Change Order

Williamson County
Animal Shelter Expansion
1855 SE Inner Loop
Georgetown, TX 78626

Change Order Number: 007

Change Order No. 7 includes the below listed Vaughn Change Proposals # 32-#39 and #41-42. For Vaughn Project No. 2491-01.

KENNEL - RENOVATION -
POWER PLAN - LEVEL 1

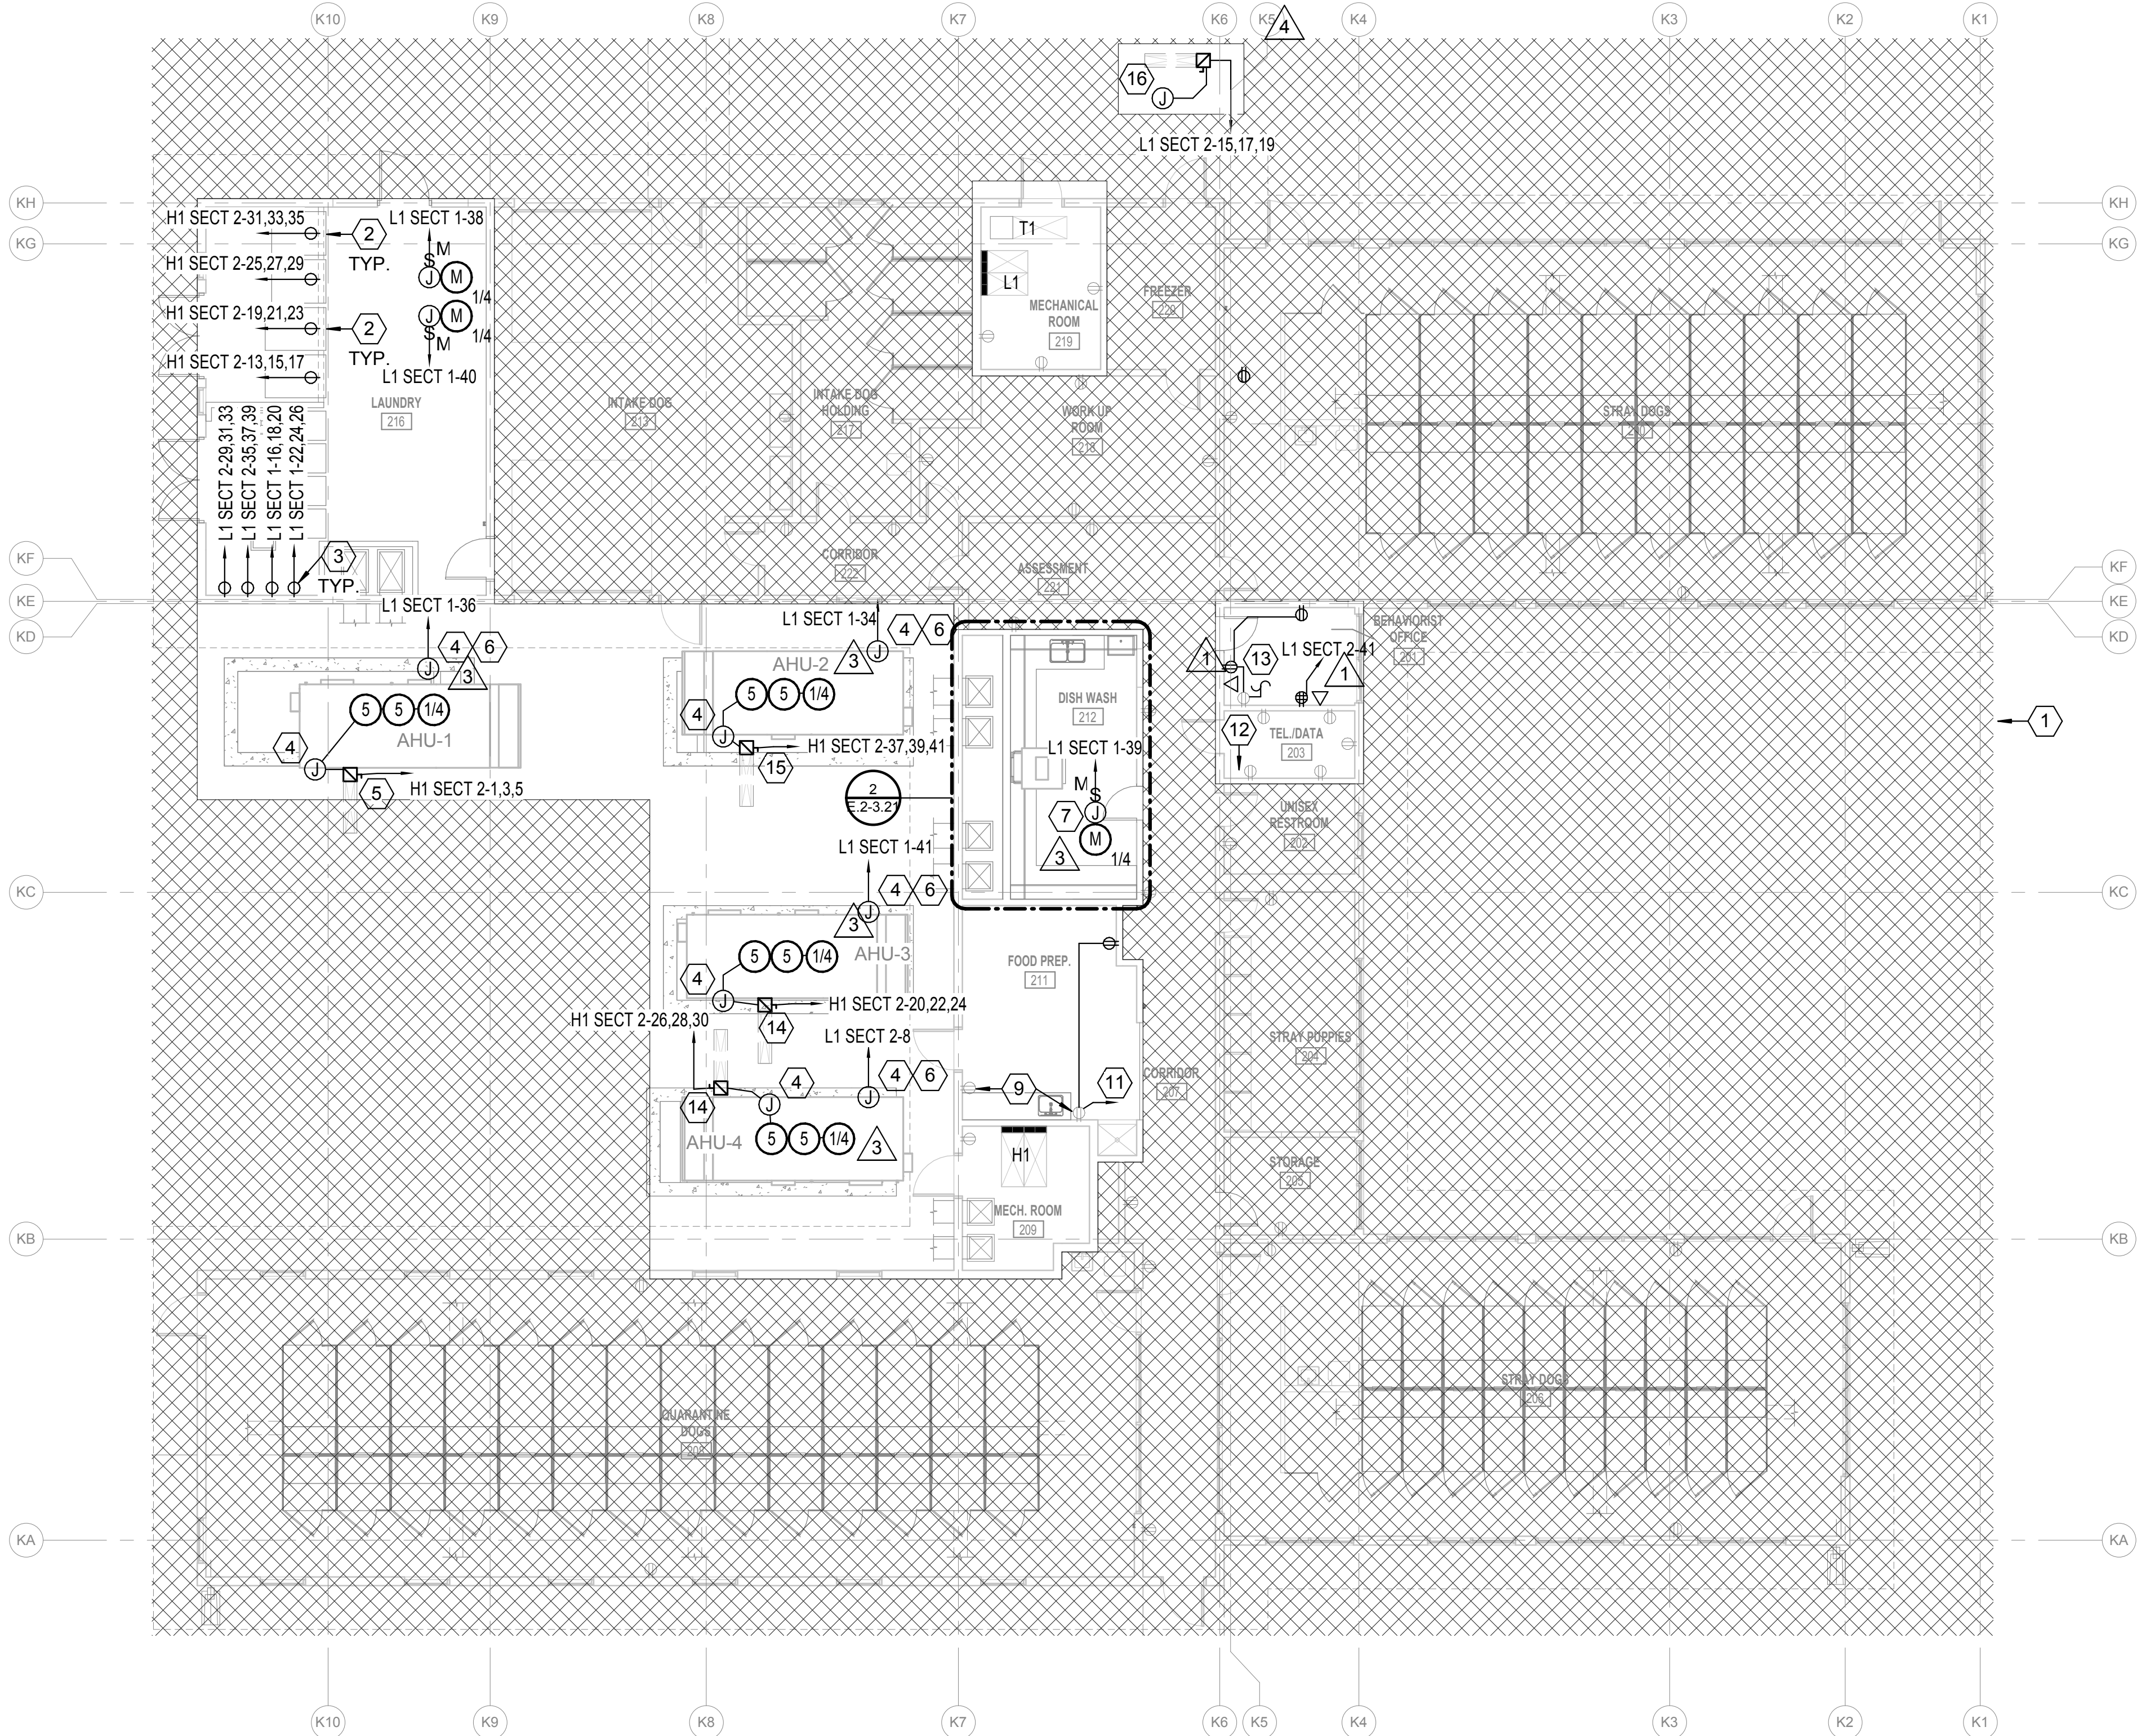
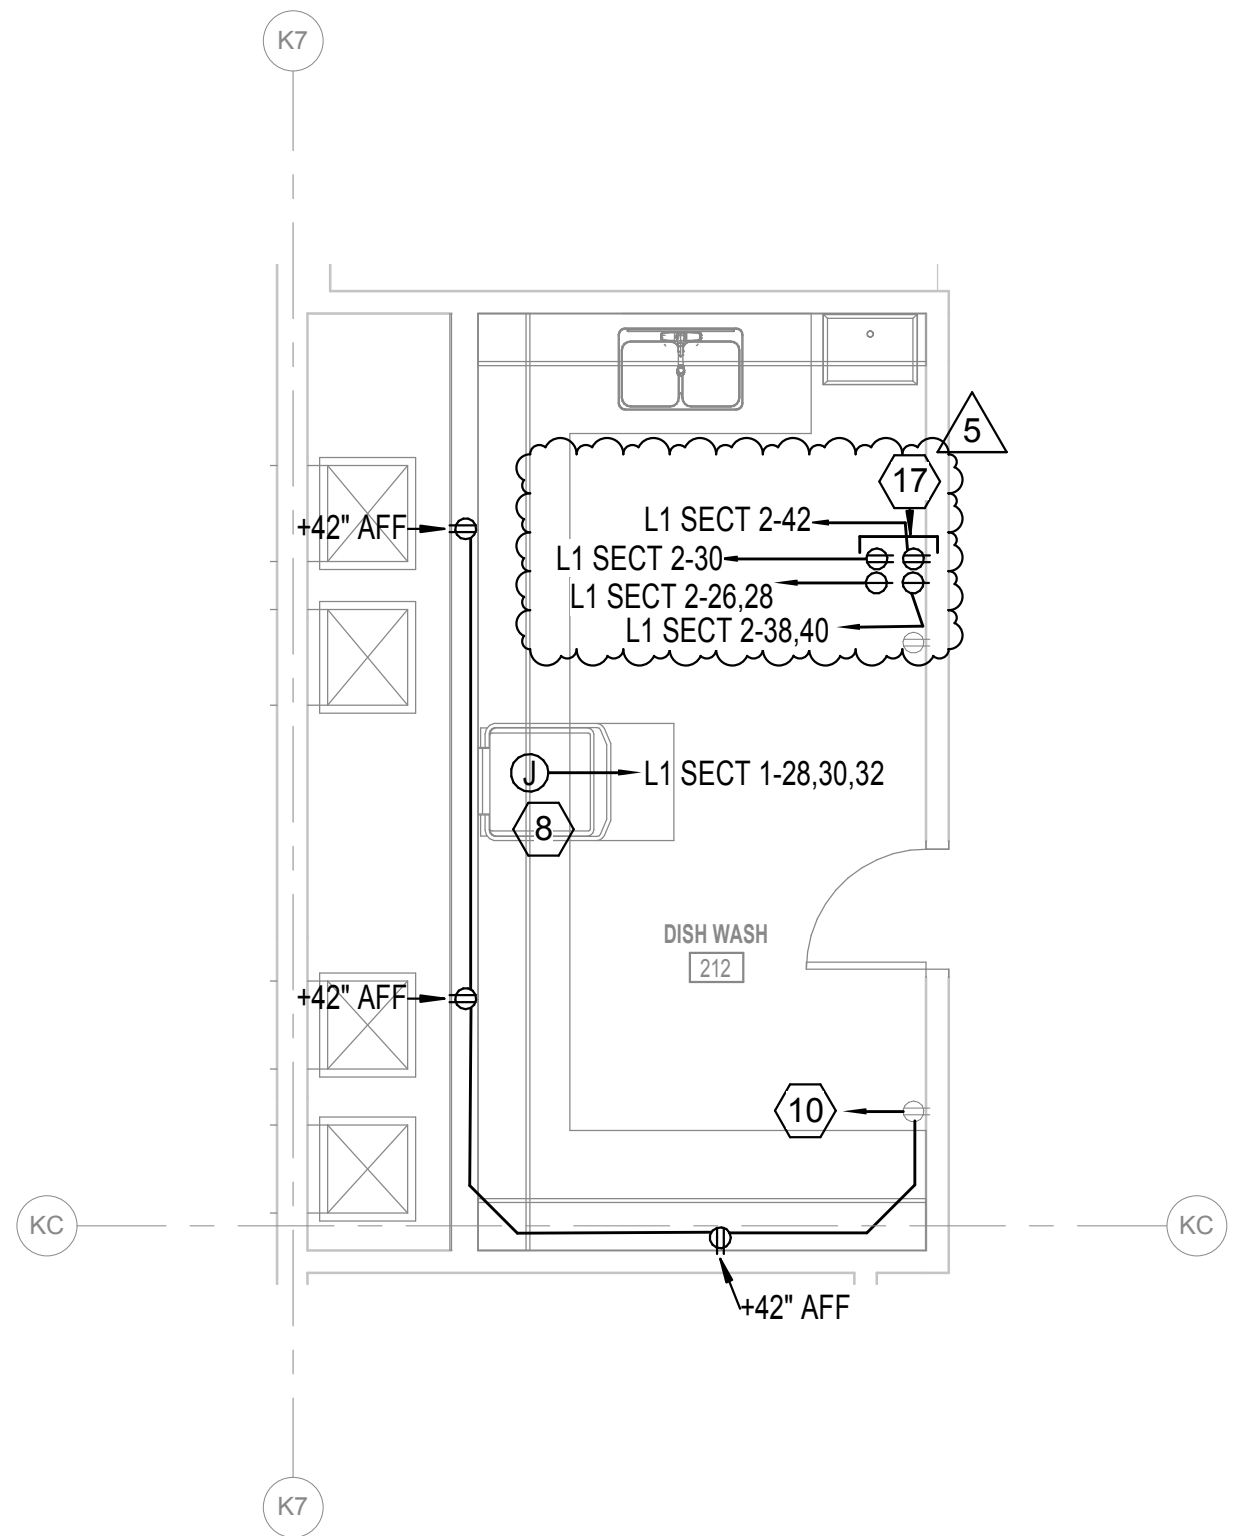
- 1 SHADED AREA NOT IN SCOPE OF POWER RENOVATION.
- 2 PROVIDE POWER TO DRYERS AT 90" AFF IN BULKHEAD. COORDINATE WITH OWNER/ARCHITECT FOR FINAL NUMBER OF UNITS AND EXACT LOCATION. PROVIDE NEMA 16-50R.
- 3 PROVIDE POWER TO WASHING MACHINES. COORDINATE WITH OWNER/ARCHITECT FOR FINAL NUMBER OF UNITS AND LOCATION. PROVIDE NEMA L14-20R.
- 4 FACTORY INSTALLED JUNCTION BOX FOR CONNECTION BY DIV 26. DIV 26 NOT TO PENETRATE HOUSING OF MECHANICAL EQUIPMENT. WIRING FROM JUNCTION BOX TO LOAD BY MANUFACTURER.
- 5 PROVIDE NEMA 3R, 60A/3P/600V RATED DISCONNECT FUSED AT 50A. UNISTRUT MOUNT DISCONNECT TO EQUIPMENT PAD. COORDINATE LOCATION WITH DIV 23.

- 15 PROVIDE NEMA 3R, 100A/3P/600V RATED DISCONNECT FUSED AT 70A. UNISTRUT MOUNT DISCONNECT TO EQUIPMENT PAD. COORDINATE LOCATION WITH DIV 23.
- 16 RELOCATED FREEZER CU. RUN CONDUIT ALONG WALL PARALLEL TO THE REFRIGERANT LINE. INSTALL RELOCATED DISCONNECT. REUSE EXISTING CIRCUIT BREAKER IN PANEL L1 SECT 2.
- 17 PROVIDE POWER TO STACKED WASH-DOWN PUMPS. PROVIDE NEMA 5-20R AND NEMA L6-30R PER PUMP. COORDINATE ELEVATIONS WITH PUMP SUPPLIER.
